ELECTRICAL—TRAILER TOW WIRING—DIFFICULT TO LOCATE AT INSTRUMENT PANEL—VEHICLES BUILT 9/1/1999 THROUGH 10/4/2000—RELOCATION PROCEDURE	Article No. 01-5-3

FORD: 2000-2001 SUPER DUTY F SERIES

Figure 1 - Article 01-5-3

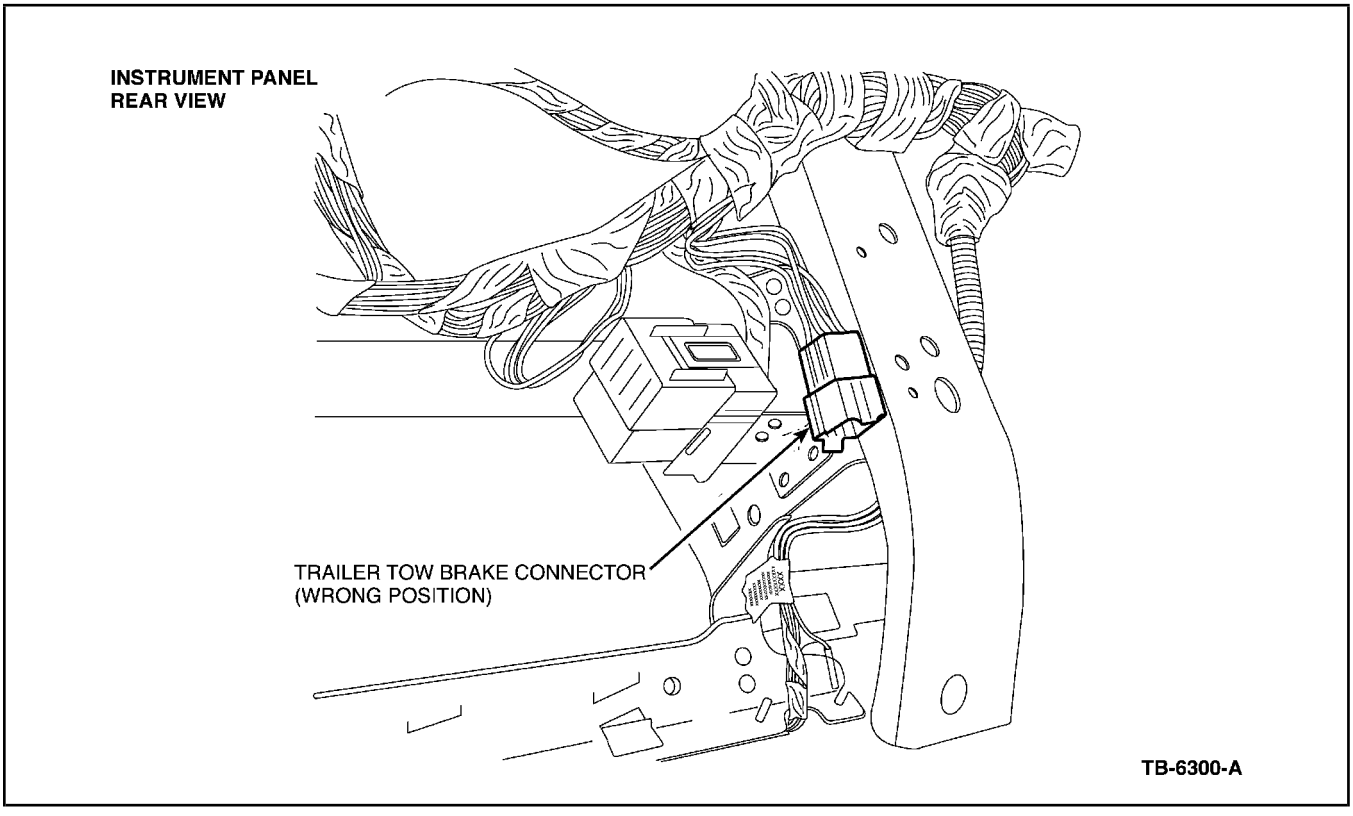
On some vehicles the trailer tow brake connector C210 (part of wiring loom -14401-) may be hard to find in the instrument panel. This may be due to the trailer tow connector being installed in the wrong location in the instrument panel.

1. Locate and remove the trailer tow connector C210 from the incorrect position in the instrument panel (Figure 1).
2. Remove the connector pin-push from its position.
3. Install the connector at the correct position (Figures 2 and 3).

Locate and reposition the connector to the proper location at the instrument panel central bracket. Refer to the following Service Procedure for details.
